TE Connectivity

Product Change Notification: E-19-014633

DEUTSCH DT Series Plug and Receptacle E-seal Grommet Color Change

12P Before and After

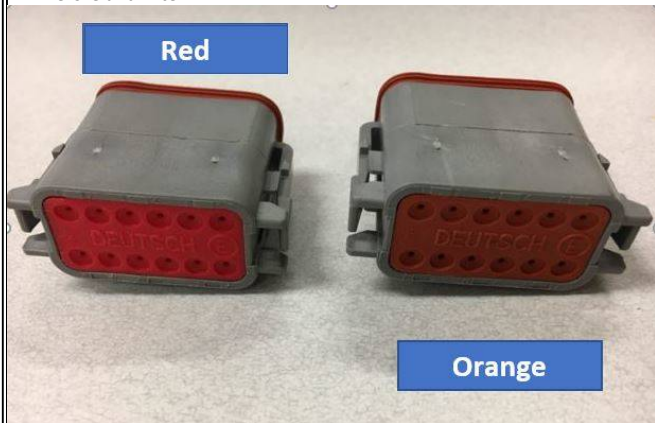
The Industrial and Commercial Transportation (ICT) business unit of TE Connectivity (TEC) is making a change to the below product drawing for E-Seal grommet Grommet (E-Seal) color change from "Red-Orange" to "Burnt Red". 114-151009 Spec has been updated.

Grommet Before and After

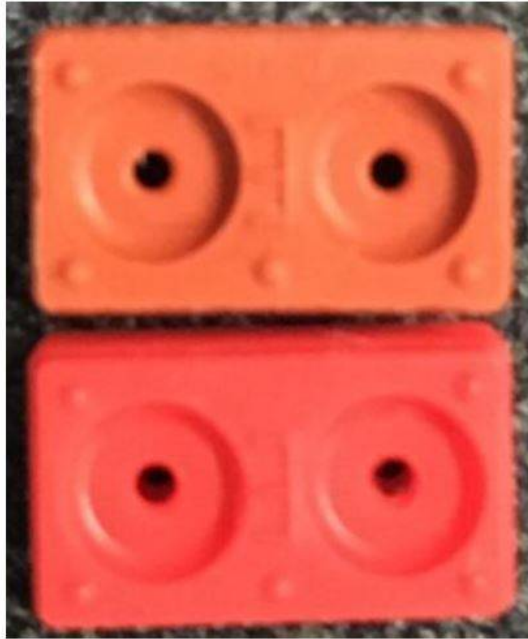
Orange (BEFORE)

Red (AFTER)
